From: Peabody, Daniel (DEQ)
Sent: Thursday, April 11, 2019 8:39 PM
To: Saric, James
Cc: Keiser, Jeff/MKE; Roth, Charles; Canar, John; Patricia.White@jacobs.com; Gustavson, Karl; Roberts, Keegan; John Kern; Kirchner, Scott; Bennett, Brian
Subject: MDEQ Comments on Area 6 Surface Water Work Plan
Attachments: MDEQ Comments_Kalamazoo River_OU5 Area 6_Surface Water Work Plan 03292019.pdf

Attached are the comments from the MDEQ on the Area 6 SWWP. I attached all of our comments on the document but inserted what I feel are the big picture comments below. It is a little hard to distinguish between what is should be sorted out “pre-deployment” vs. what can wait to be revised in the document, since the State believes the study rationale, objectives, and explaining the data analysis, handling and limitations is as (or more) important than comments/concerns that pertain to the physical installation of the equipment. Comments highlighted below are also highlighted in the document for quick reference. I will draft a cover letter tomorrow for the official comment submittal but wanted to get these into your hands tonight so you could get what you feel are “key” comments to Wood ASAP. Please add o

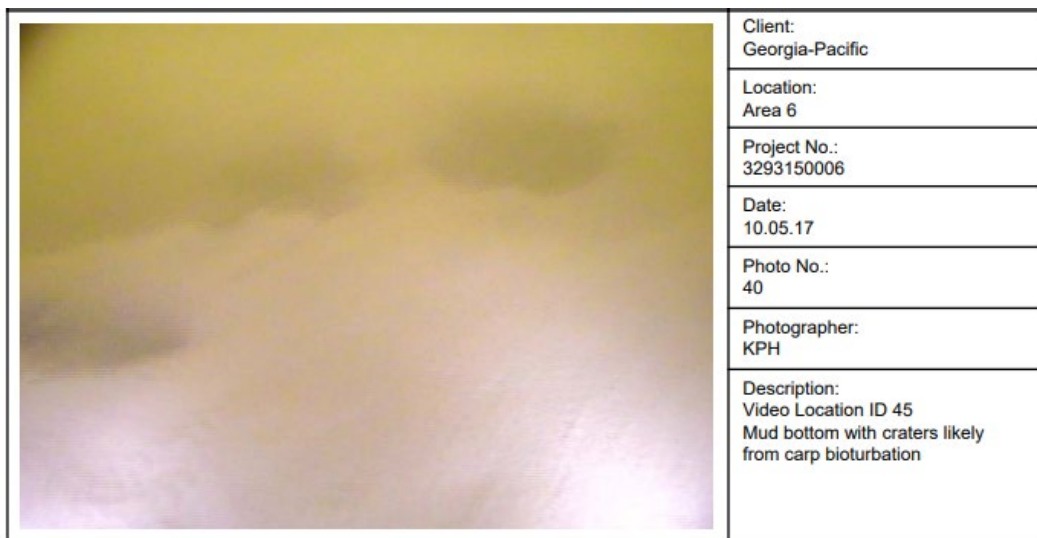
Commenting Organization: MDEQ **Commenter:**
Section: 1.3.2 **Page #: 1-5** **Lines #: 7-8**
Specific Comment #14: The “evidence of bioturbation” should be further explained. Lake-bottom environments may be more dynamic than suggested in the text. For example, in deeper lake bodies, surficial wave action is driven by wind currents but return currents moving in an opposite direction may be present deeper in the water column.

The 2017 Area 6 Video Condition Survey Report provided to the MDEQ shows what appears to be gravitational settling (loading) or perhaps *lingoid* or *lunate ripple marks*, which would be

bedform features unrelated to bioturbation, but the quality of the video is such that the identity and cause of the feature(s) cannot be determined.

In 2015, the MDEQ collected images of lake-bottom sedimentary features that appear similar to those provided in the Area 6 Video Conditions Report, in a lake (Torch Lake) that is void of

carp (0 to <0.1 catch per unit effort [The Fish Community and Fishery of the Portage-Torch Lake System, Houghton County, Michigan in 2007-08, dated June 2016]) and at the exact depth referenced in the text. Those images were shared with GP via email on March 26, 2019 and are provided below.

While the identity and cause of the lake-bottom features observed in Lake Allegan is debatable the assertion that they are the result of carp feeding or other biological activities related to carp (or other bioturbating organisms) should be made with caution without additional lines of evidence to support that claim, especially if these lake-bottom features are being used to justify placement of HyST or OPTICS monitoring stations.
